Change No. 18
License No. DPR-16

SAFETY EVALUATION BY THE DIRECTORATE OF LICENSING

PROPOSED CHANGES TO THE TECHNICAL SPECIFICATIONS

SUPPLEMENT 1
TO THE
TECHNICAL REPORT ON
DENSIFICATION OF GENERAL ELECTRIC REACTOR FUELS

Figure 2.5.1. Densification of several alumina compacts heated in oxygen (O) and hydrogen (H), respectively; from Coble, reference 13.

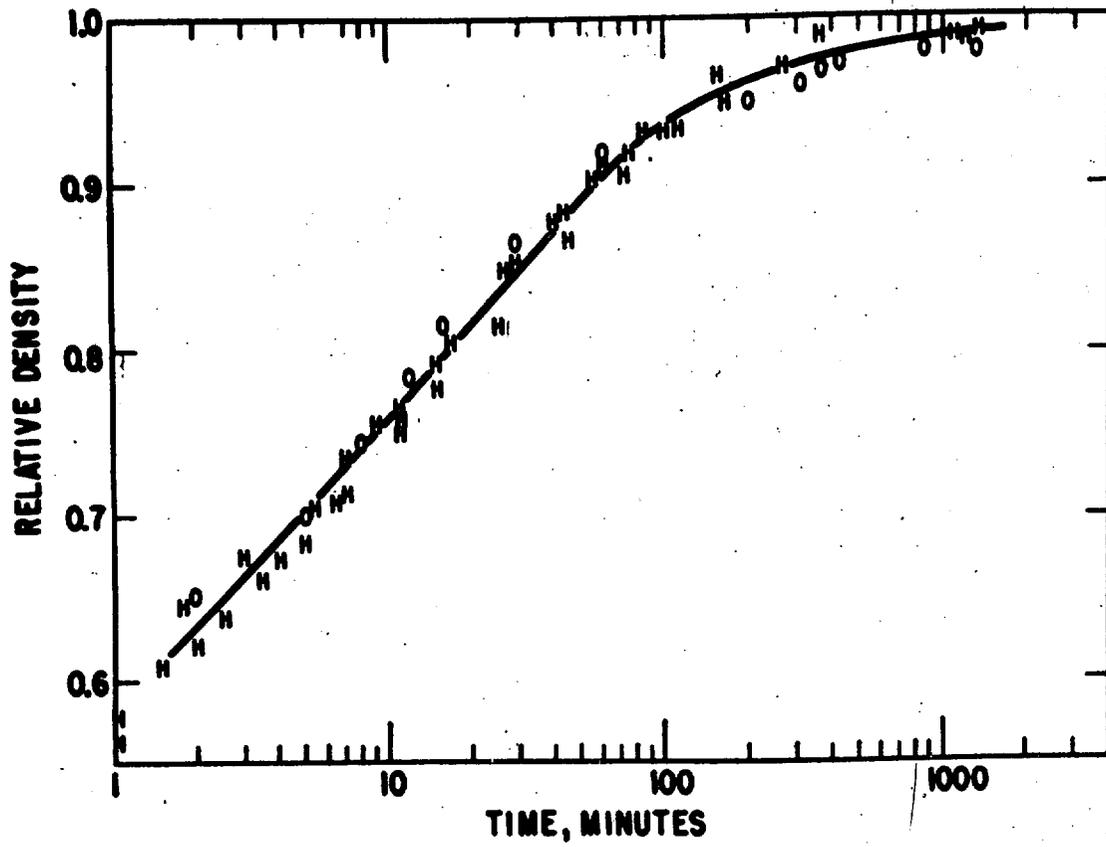
Figure 2.5.1 shows a measured densification curve for alumina, which is given as an example of a typical ceramic. This figure is from reference 13, which was used by Marlowe to justify the logarithmic time dependence in Equation (1). The curve is linear below about 90% T.D., but above 90% T.D. it is decidedly curved. Assuming that the same behavior is found in UO_2 , M will not be uniquely defined above about 90% T.D., the region of current interest, and the value of M determined from a resintering anneal will depend on the resintering time. Similar comments may apply to grain growth curves.

Figure 2.5.2. Reduction in stack length as a function of burnup; from Hanevik et al. (Halden), reference 18.

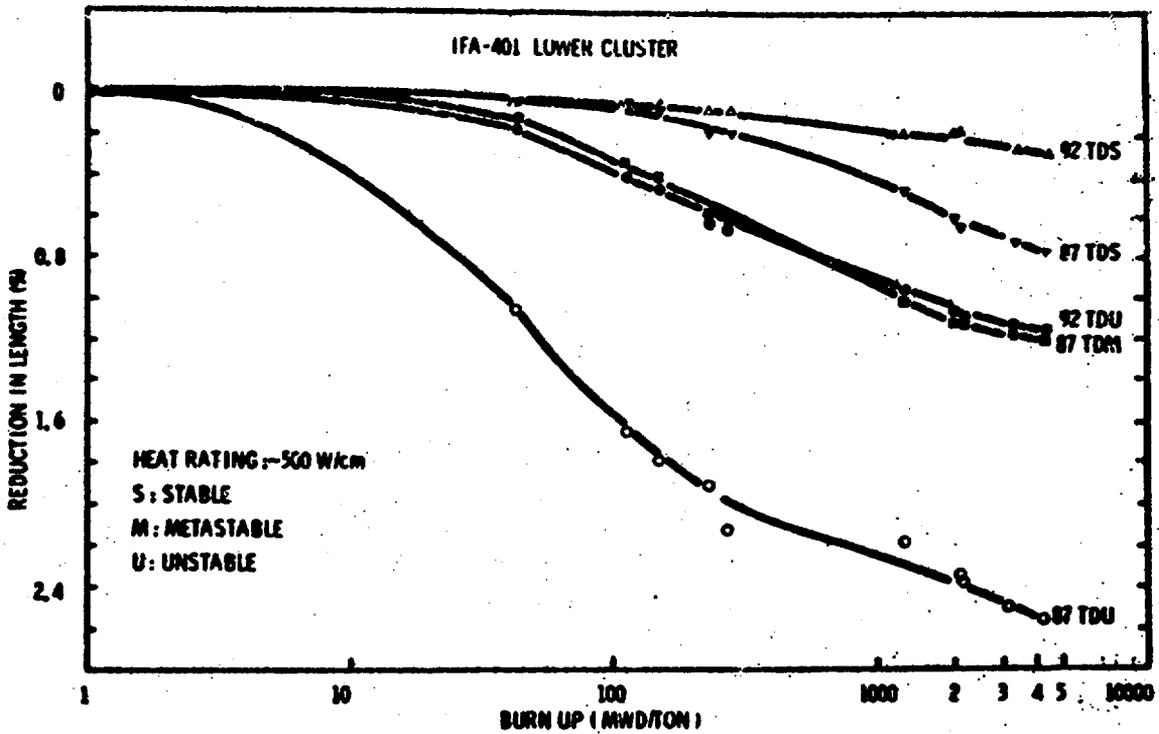
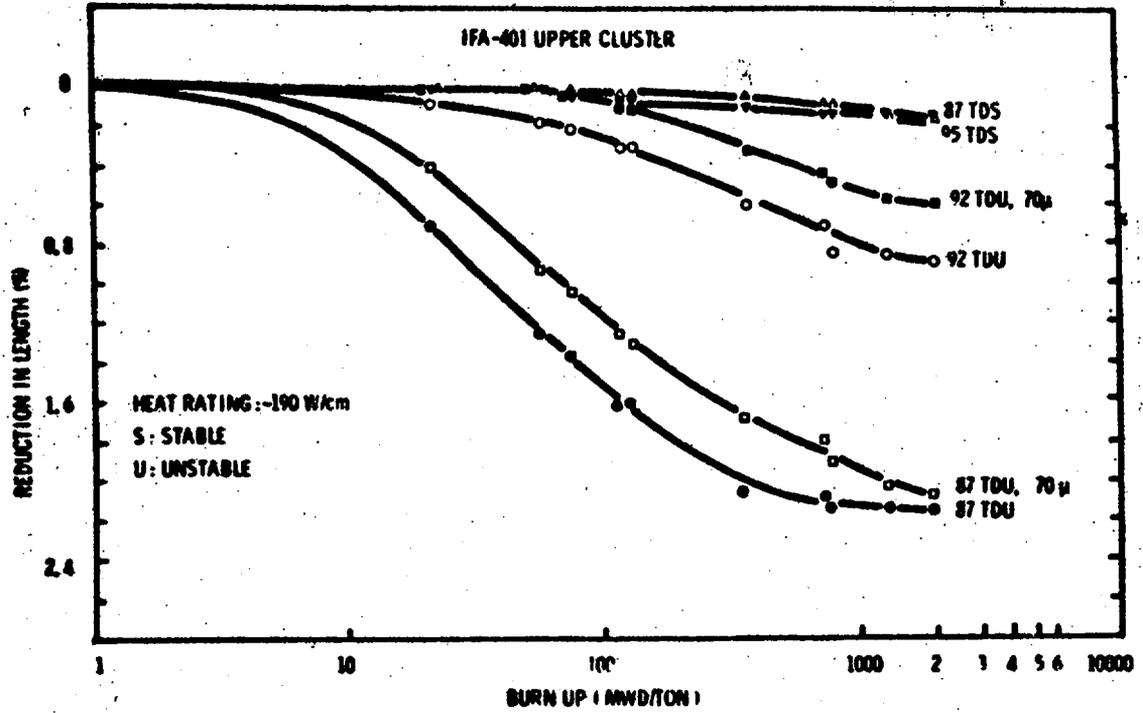
Some of the Halden data¹⁸, against which the G. E. model was tested, are shown in Figure 2.5.2. These curves generally indicate a peak density (maximum reduction in length) at about 4,000 MWd/tU, although one of the curves indicates an even lower burnup. In addition to the Halden data, non-proprietary Westinghouse data²¹ indicate a maximum density at an exposure between 4,000 and 10,000 MWd/tU, and these data are shown in Figure 2.5.3. While no statistical analysis has been performed by us on these data, it is clear that a predicted maximum density that occurred significantly later than 4,000 MWd/tU would be neither realistic nor conservative. We believe that rate constants similar to the ones currently being used by G.E.⁹ will produce density maxima at about 4,000 MWd/tU and that a 4,000 MWd/tU restriction will have little or no effect. However, if smaller rates constants are found that are similar to earlier values used by G.E.¹¹, the 4,000 MWd/tU restriction may affect the result significantly and in a conservative manner.

Figure 2.5.4. In-reactor stack length changes compared to out-of-reactor resintering length changes adjusted to correspond to resintering at 1700°C for 24 hours.

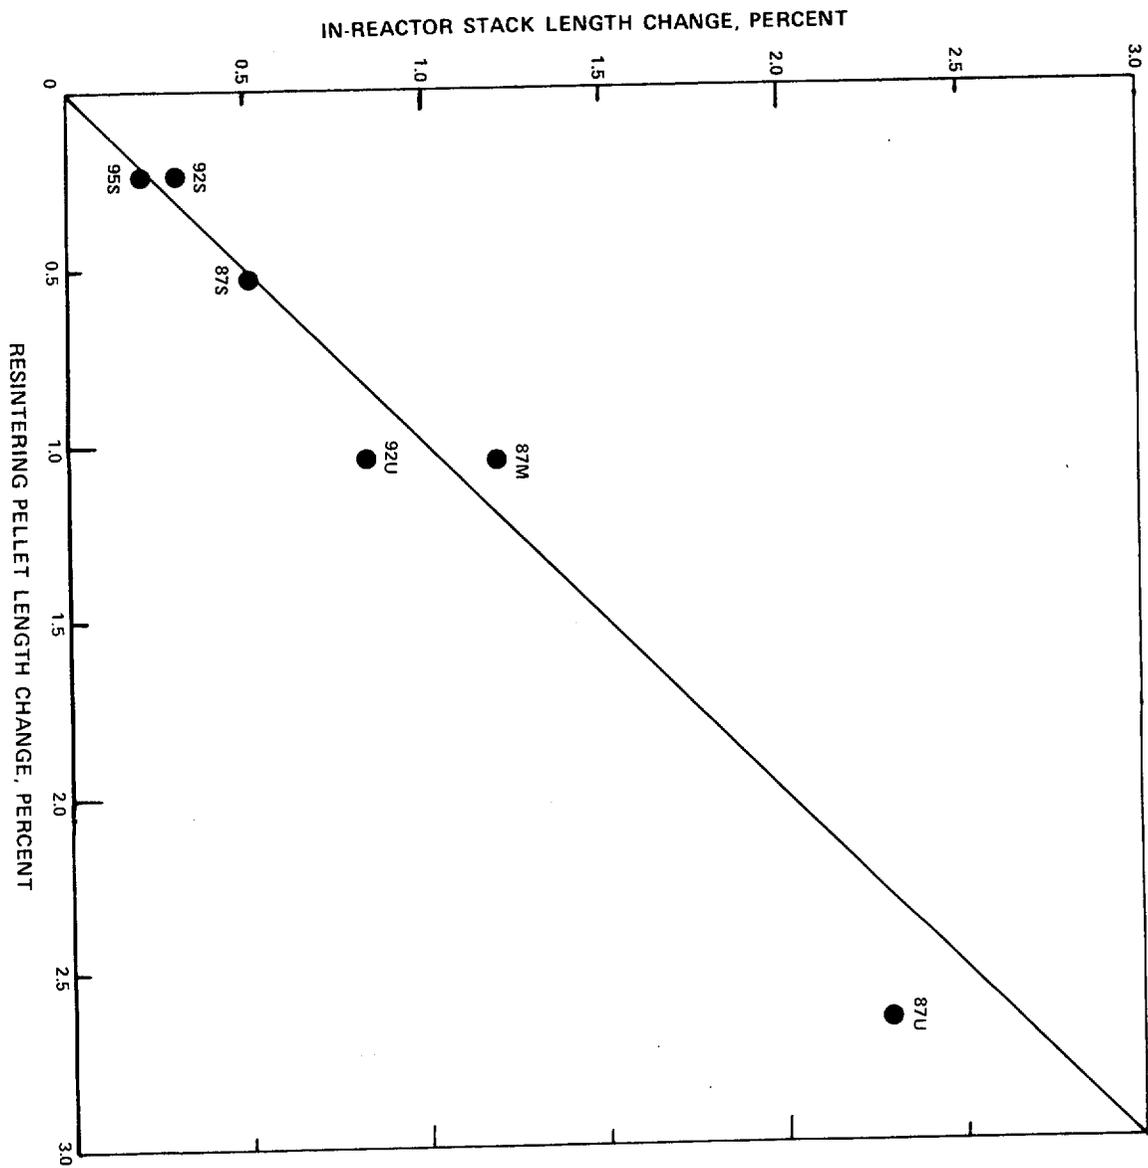
Figure 2.5.4 exhibits excellent correlation between resintering pellet-length for 24 hours. The original resintering data were taken at 1625 C for 5 hours. The extrapolation also utilized sintering curves supplied by G.E.²².

Figure 4 exhibits excellent correlation between resintering pellet-length changes and in-reactor pellet-length changes around 4,000 MWd/tU.

Points below the 45° equivalence line indicate greater out-of-reactor densification and are thus conservative. Since out-of-reactor dimensional changes are isotropic and in-reactor dimensional changes are anisotropic¹¹, all points will be moved downward. If $\Delta L/L$ is taken as $1/2 \Delta V/V$, a factor of 2/3 would apply to the in-reactor values, moving

all data points below the equivalence line and implying that in-reactor densification is less than densification produced out-of-reactor at 1700°C for 24 hours.

FIGURE 2.5.5

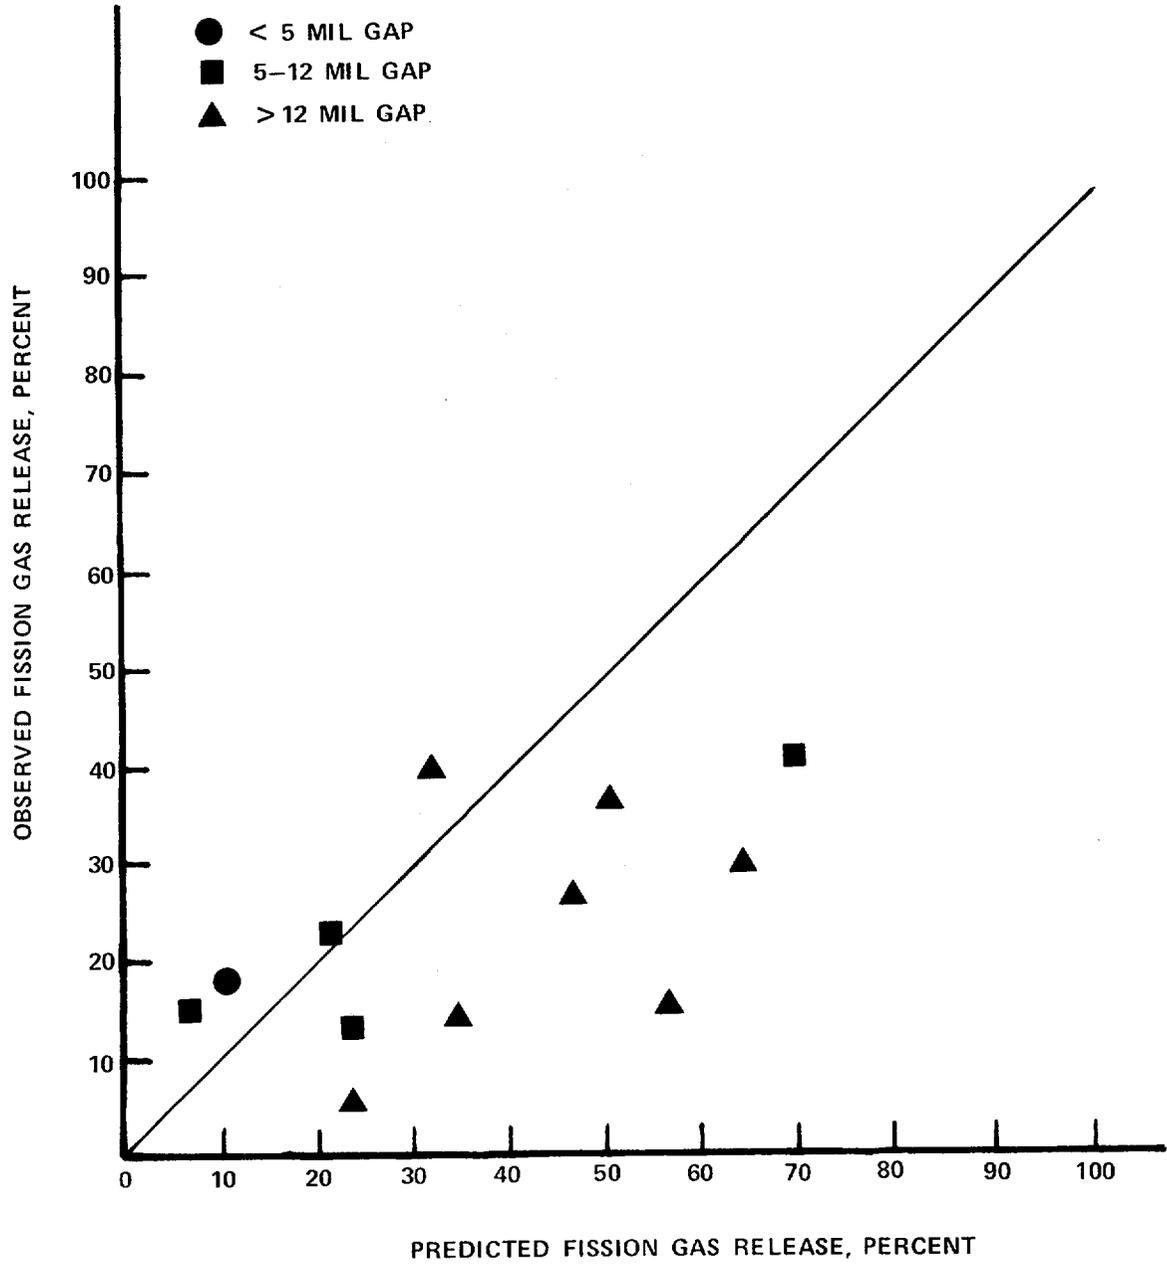
model is also used by the staff in GAPCON-THERMAL-I. Figure 2.5.5 shows a plot of the GEGAP-III calculations for fission gas release compared with experimental data. These results show that the fission gas release model is, in general, conservative and is therefore acceptable to the staff.
